2.5 Geology, Seismology, and Geotechnical Engineering

In Section 2.5, "Geology, Seismology, and Geotechnical Engineering," of the SSAR, SERI provided a detailed description of the geological, seismological, and geotechnical engineering properties of the ESP site. In this SER, Section 2.5.1, "Basic Data," describes basic geological and seismological data, especially the data published since 1986 for the area within a 200-mile radius of the ESP site, and presents updated seismic sources. Section 2.5.2, "Vibratory Ground Motion," evaluates the vibratory ground motion for the ESP site and analyzes the safe-shutdown earthquake (SSE) ground motion. Section 2.5.3, "Surface Faulting," describes the potential for surface faulting at or near the surface of the ESP site. Section 2.5.4, "Stability of Subsurface Materials and Foundations," presents the results of site geotechnical investigations and discusses the stability of subsurface materials and foundations. Section 2.5.5, "Stability of Slopes," defers the analyses for slope stability at the site and dam performance, respectively, to the COL stage. Finally, Section 2.5.6, "Embankments and Dams," briefly states that no embankments exist wi

Figure 2.5.4-5 (Updated final version of SSAR Figure 2.5-87)
 Shear Modulus Reduction Curves For Loess

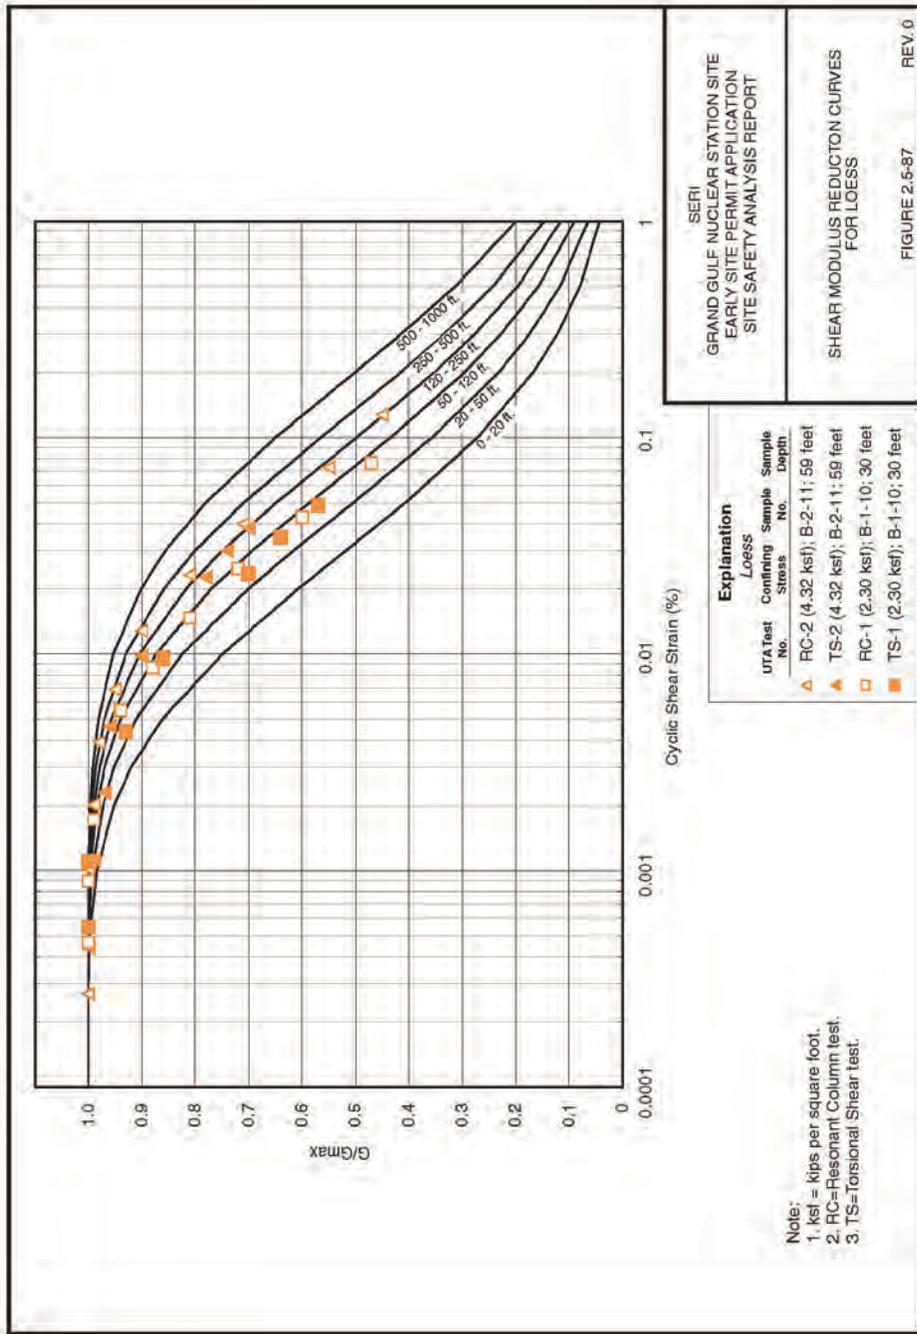
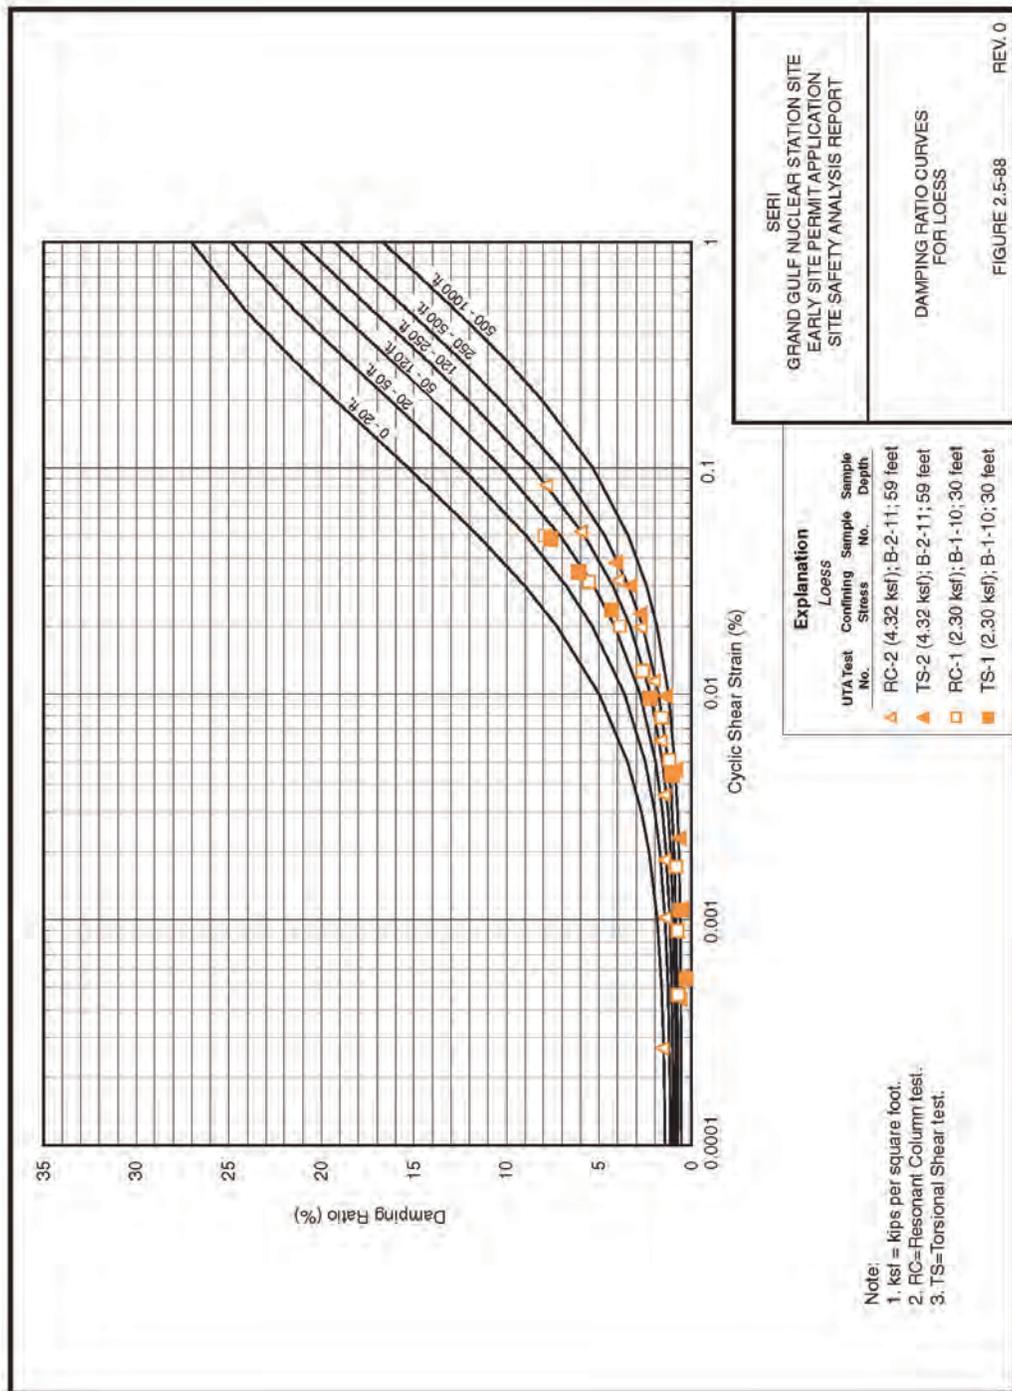
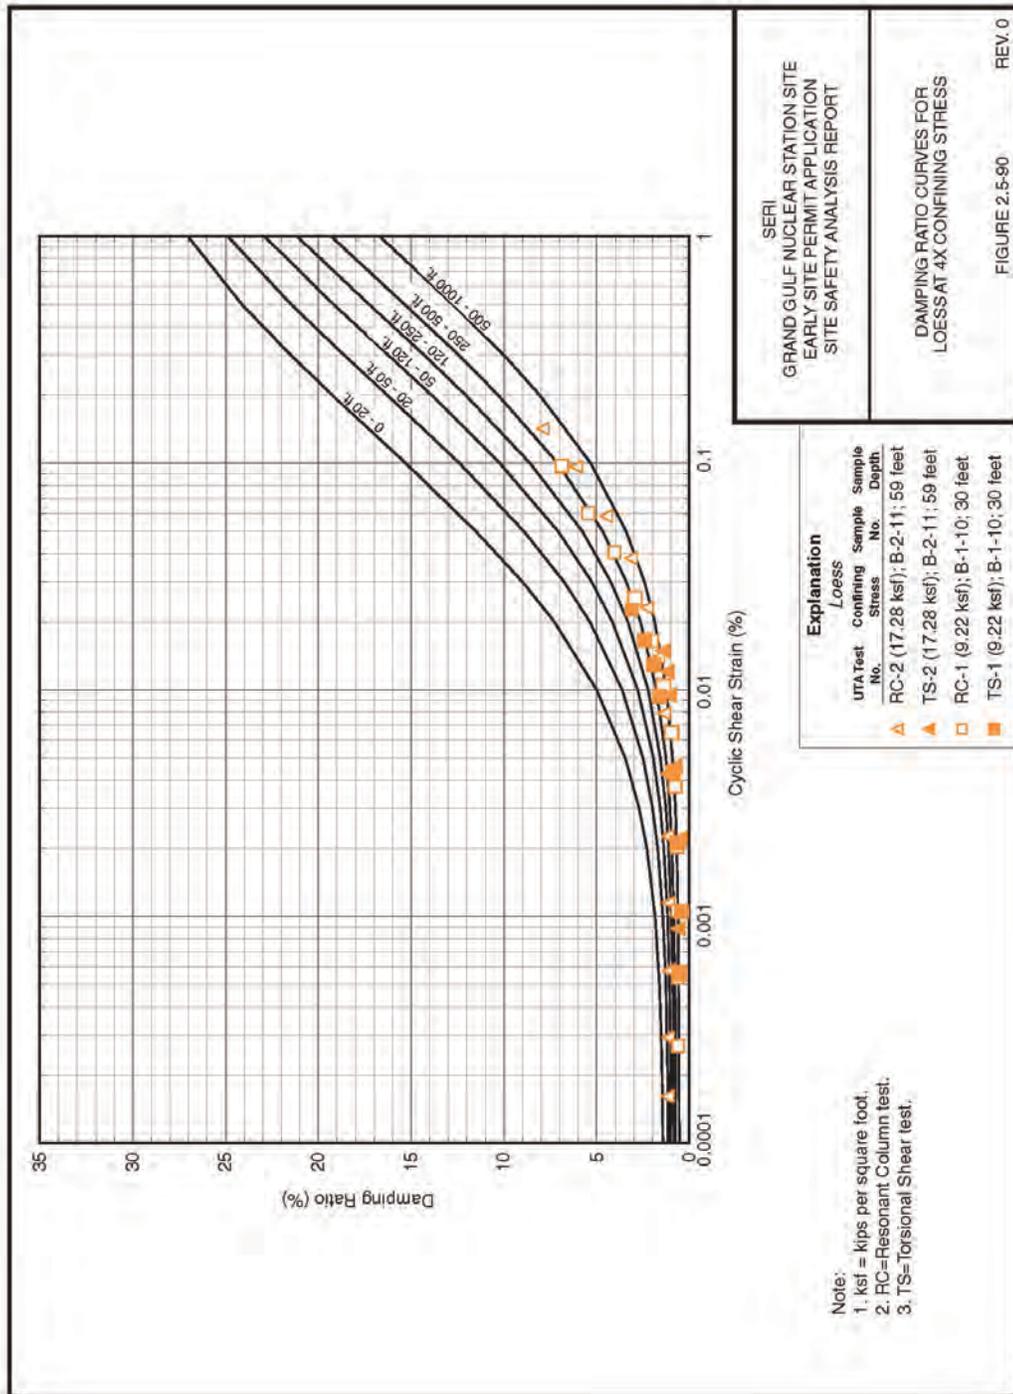
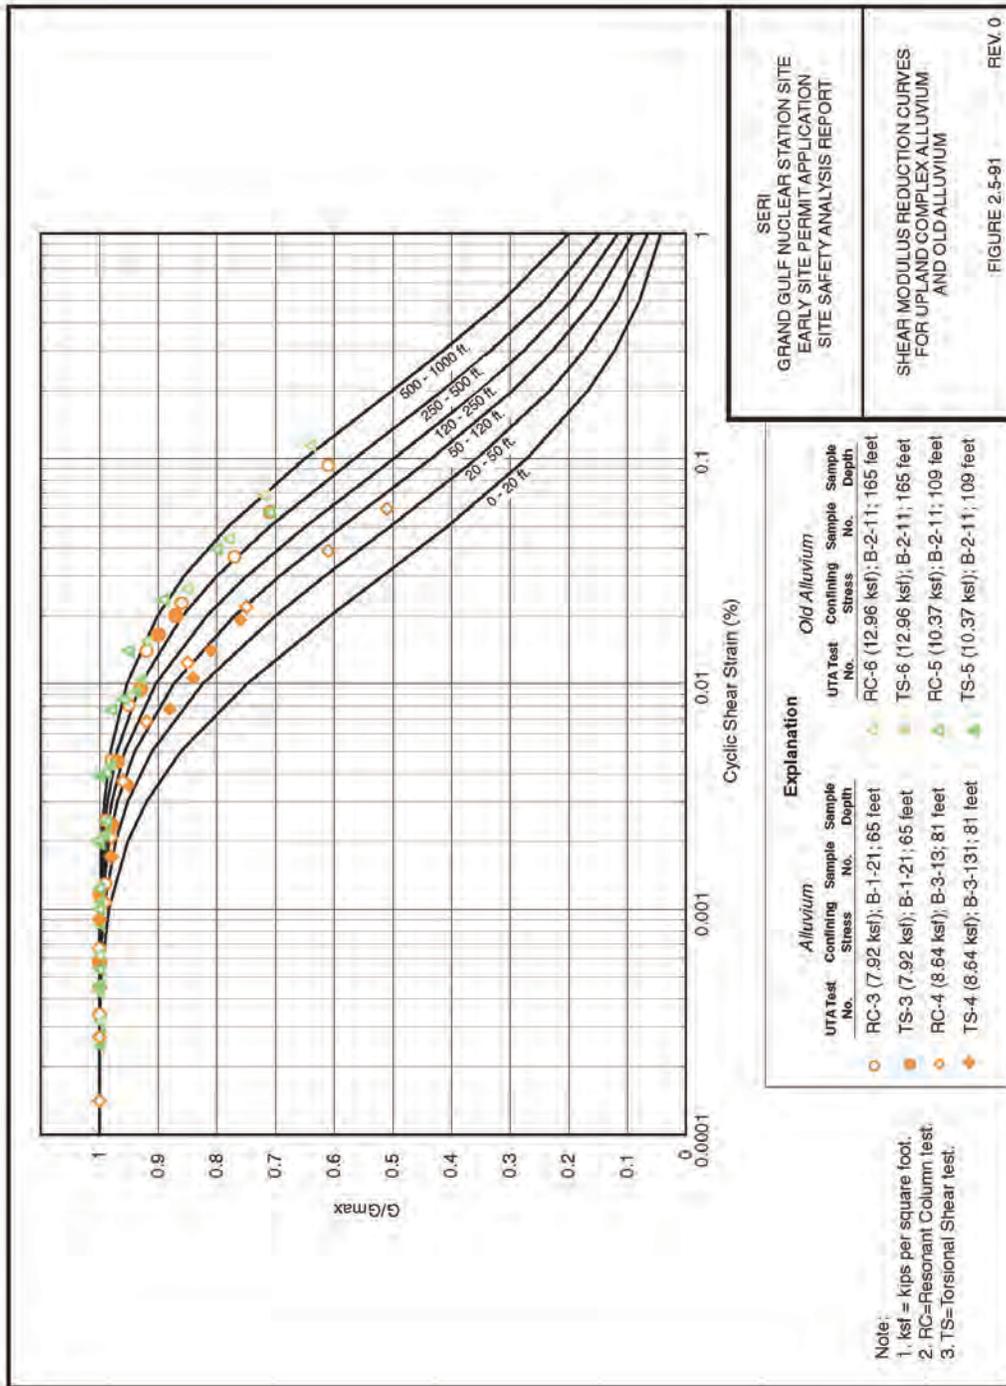
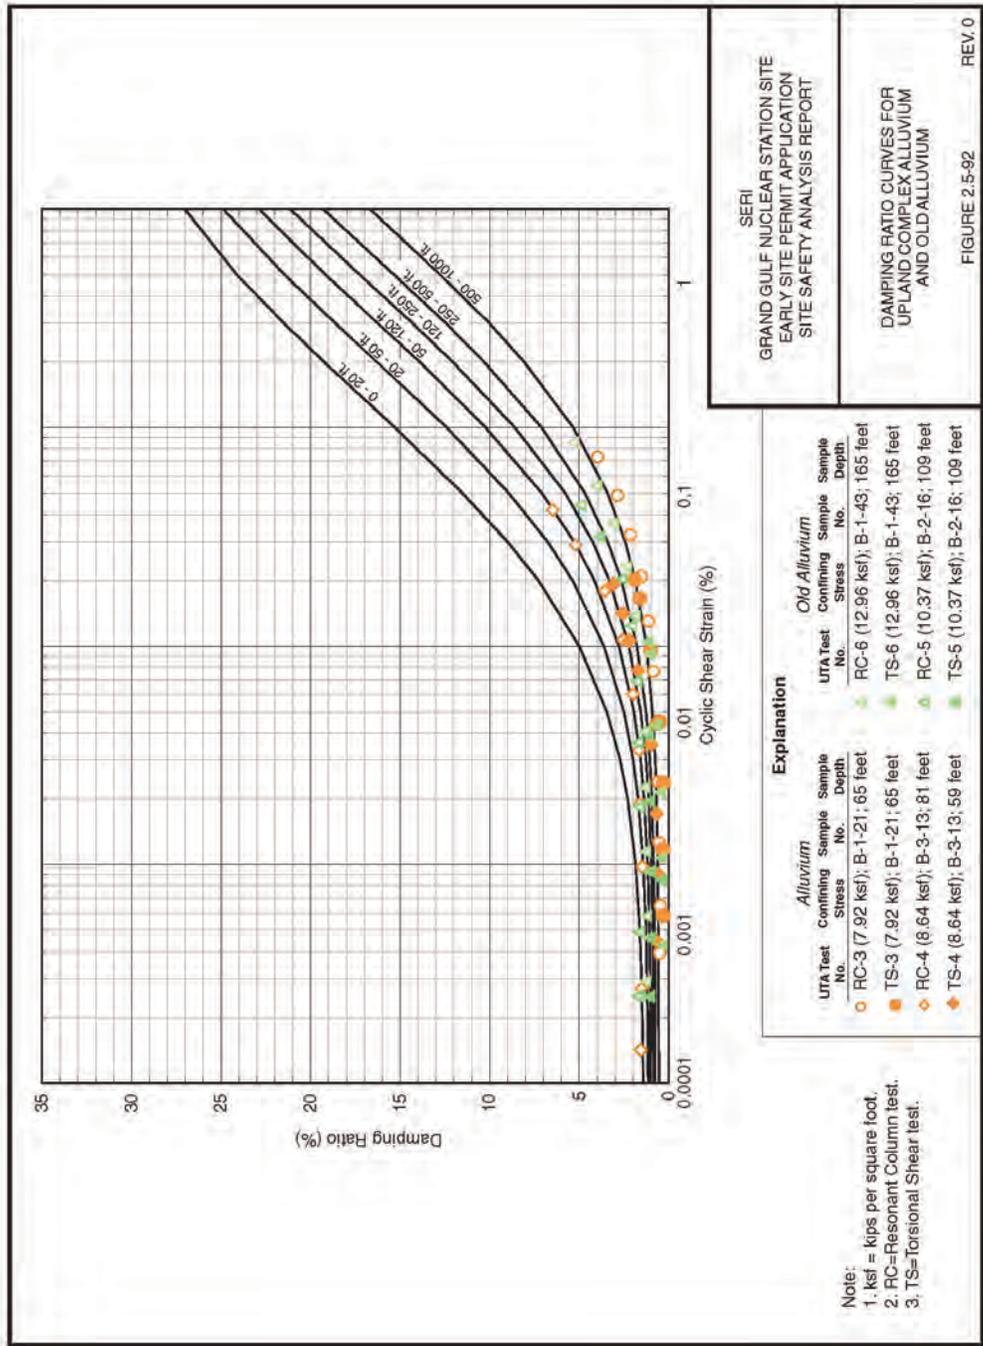
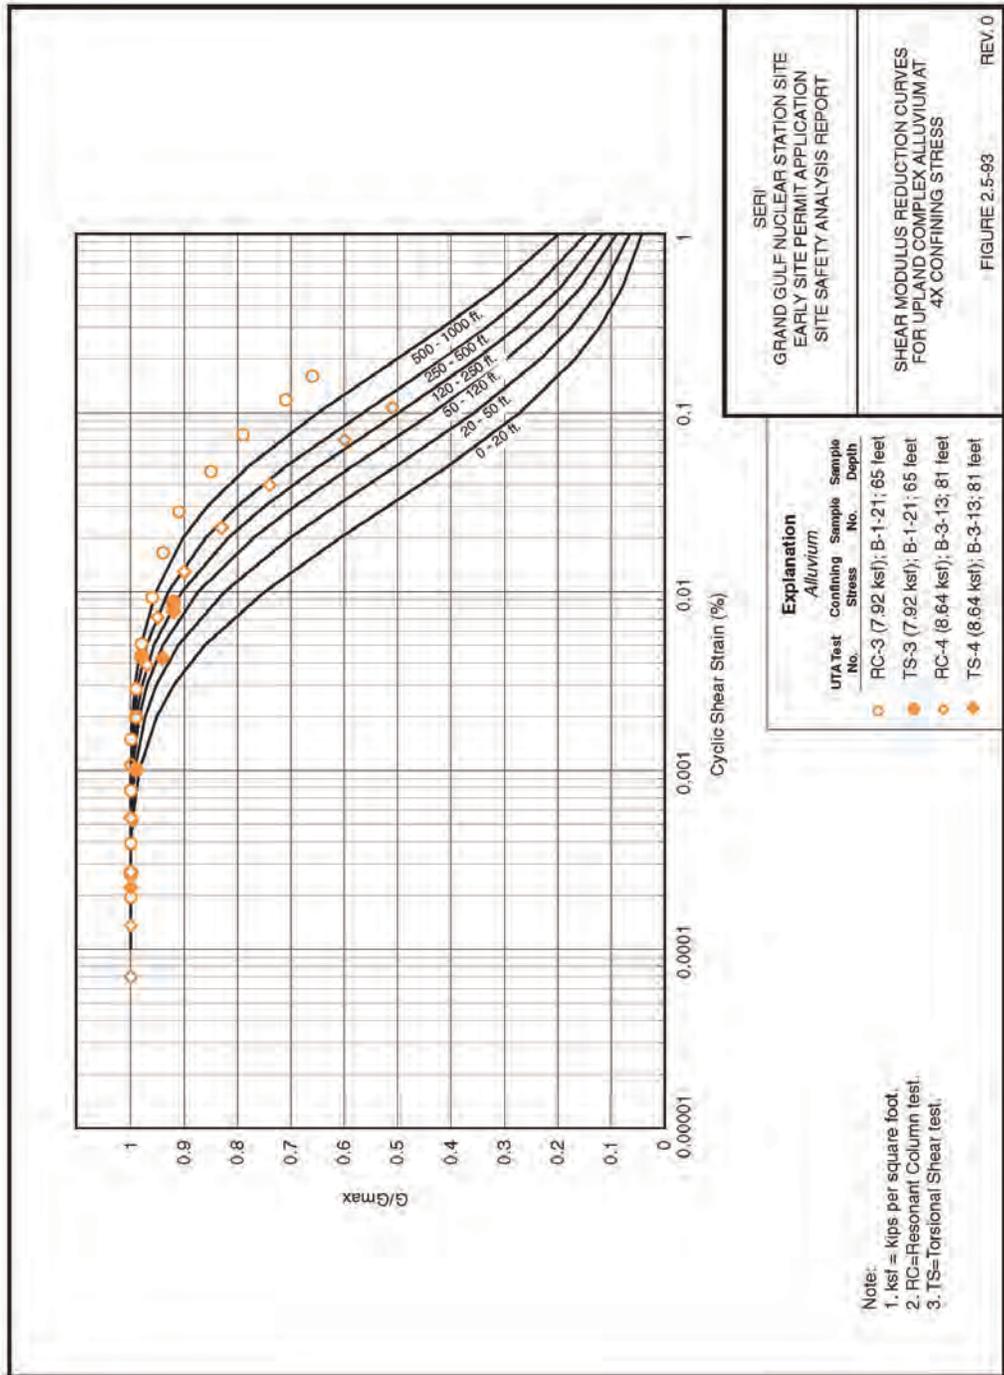
- Section 11.0 of ER-02 suggests that the laboratory results for specimens UTEXAS 1, 2, and 6 should be corrected to account for the effects of sample disturbance and/or underestimation of effective confining stress.

In RAI 2.5.4-7, the staff asked the applicant to provide its rationale for not incorporating these effects in the site response calculations and to evaluate the potential impact of these modifications on the computed surface UHRS. In its response, the applicant referred to its response to RAI 2.5.4-6 and stated that the analysis and selection of the appropriate EPRI-TR curves for shear modulus reduction and hysteretic damping fully account for the effects of possible disturbance to the test specimens resulting from stress release during sampling, as well as possible movements during testing. The applicant considered the effects of sample relaxation by examining the results from testing soils at both the estimated in situ confining stress and 4 times the estimated in situ confining stress. The applicant plotted these two data sets together on the EPRI-TR base curves as shown in Figures 2.5.4-5 through 2.5.4-12, which replicate SSAR Figures 2.5.4-87 to 2.5.4-94. The two data sets were weighted to select the most representative EPRI-TR curve.

In its response, the applicant further stated that the shear modulus reduction and damping curves adopted for use in the site response analysis represent the best fit to the dynamic soil test results that account for the effects of soil disturbance and overconsolidation. The applicant also considered the uncertainty and variability in these values in the site response modeling by developing randomizing curves about the selected base case EPRI-TR curves using an assumed lognormal distribution. The applicant further discussed the randomization process in its response to RAI 2.5.4-8 (for shear wave velocity input). The applicant considered that the EPRI-TR curves selected for the base case for site response analysis are appropriate for the site soil conditions and account for both sample disturbance and overconsolidation. Therefore, incorporation of these issues would not impact the computed surface UHRS.
